EXAMINATION REPORT - 50-327/OL-86-02

Facility Name: Sequoyah Nuclear Plant

NRC Resolution of Facility Comments to Written Exam

PRESENT DESIGN

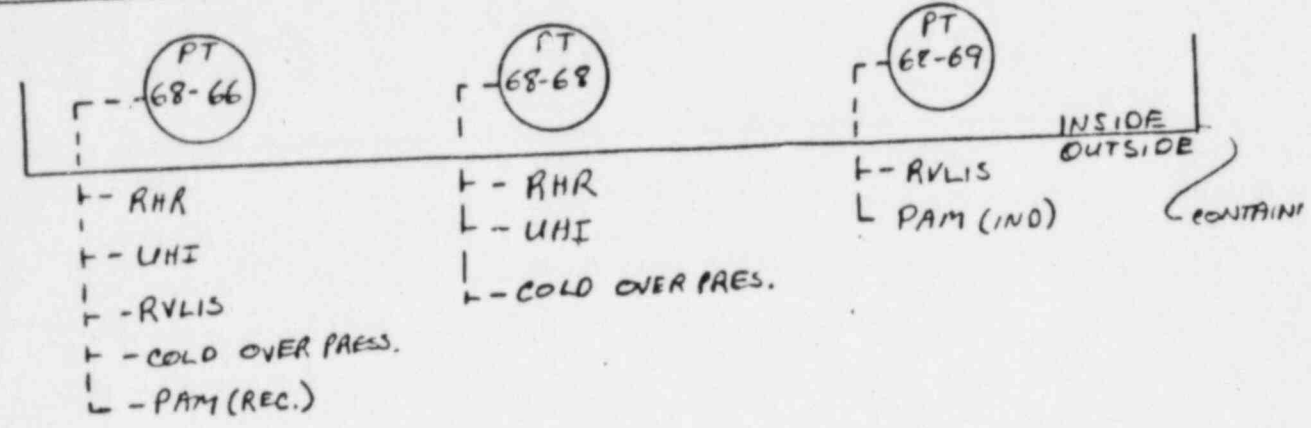
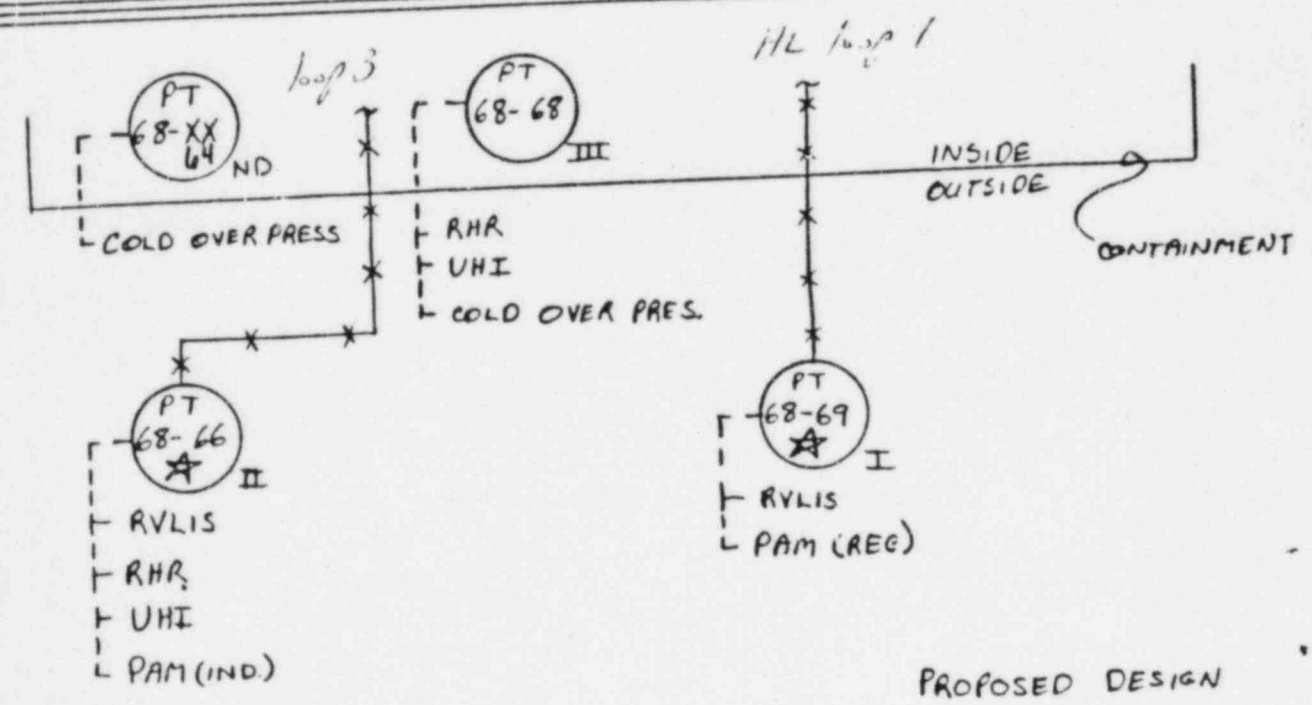
6.21 The question asks what control or protection SIGNAL is generated by the
3.15 pressure instrument on T-hot leg.

In addition to the answer given on the key any one of the following
should also be accepted:

- 1) Cold over press input
- 2) RCS Subcooling meter input
- 3) RVLIS Input
- 4) RHR interlock 380# and 700#

★ THESE INSTR. TEE MECHANICALLY INTO RVLIS BETWEEN THE HYDRAULIC ISOLATORS (XIS) AND LEVEL XMTA (LT)
 ref 47W 610-68-7

NRC Resolution: Disagree. The question asks for control or protective signals. RCS Subcooling meter and RVLIS are for indication only. COPS, however, does provide control/protection and the answer key has been modified to accept COPS.

ALL STEAM DUMP VALVES FAILED OPEN - 100% POWER

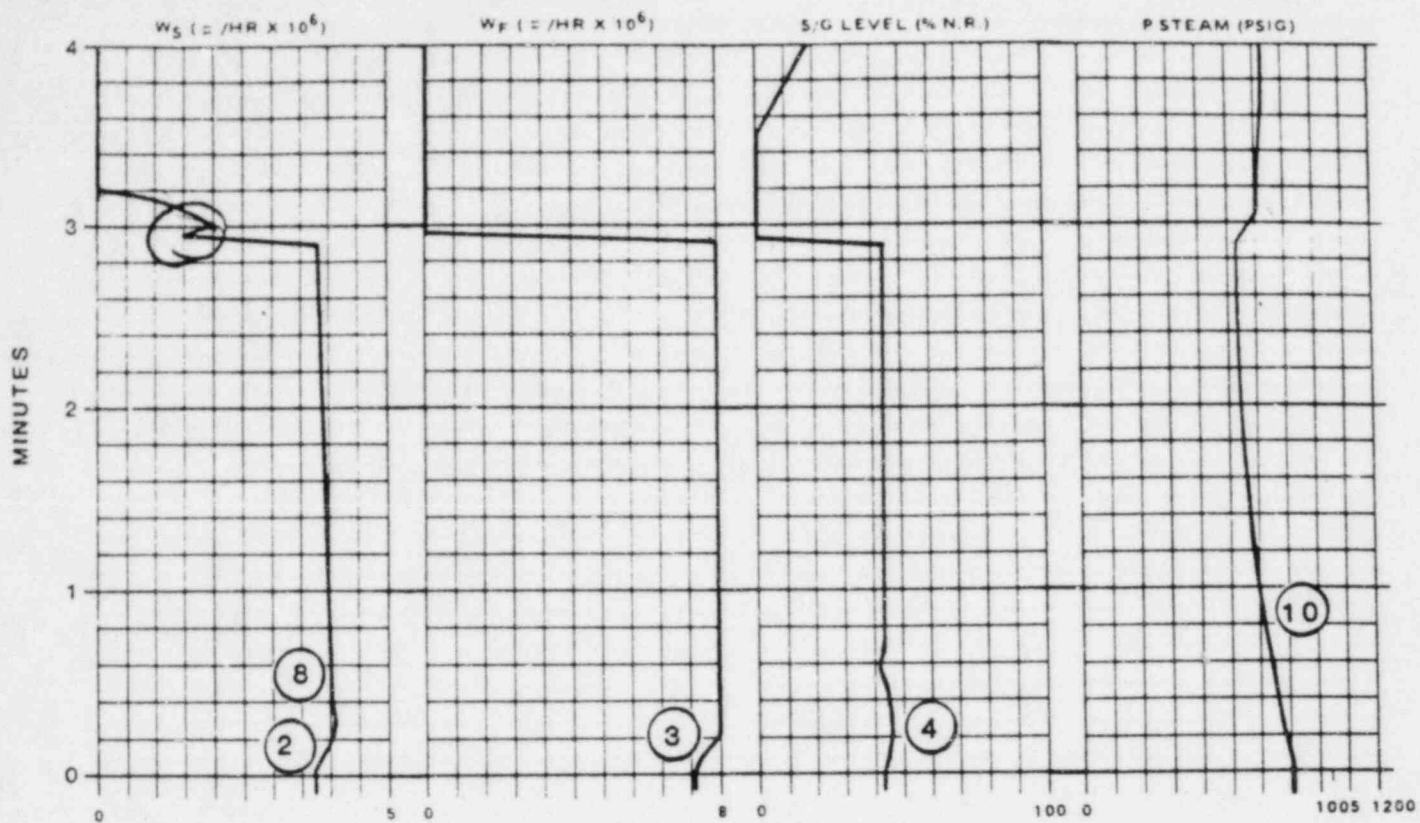
5.20 b. Answer key states outward rod motion stops due to OPAT. The
OPAT rod stop/runback is at 3% below the OPAT trip setpoint
~109% - 3% = ~106% power.

Because the NIS power range rod step is at 103% power (lower than
OPAT). The correct answer is NIS C-2 rod stop prevented
outward rod motion.

Answer key should allow NIS rod stop or the OPAT rod stop.

5.20 c. Answer key states the SF indication decreases due to P steam
decrease. However, because the S/G press is decreasing, the
steam flow should decrease because flow is proportional to the
 $\sqrt{\Delta P}$

Answer key should be revised to accept statement that there is
less driving force in S/G (lower S/G press); therefore SF
decreases.

NRC Resolution: Agree. The answer key has been modified to add an additional correct answer.
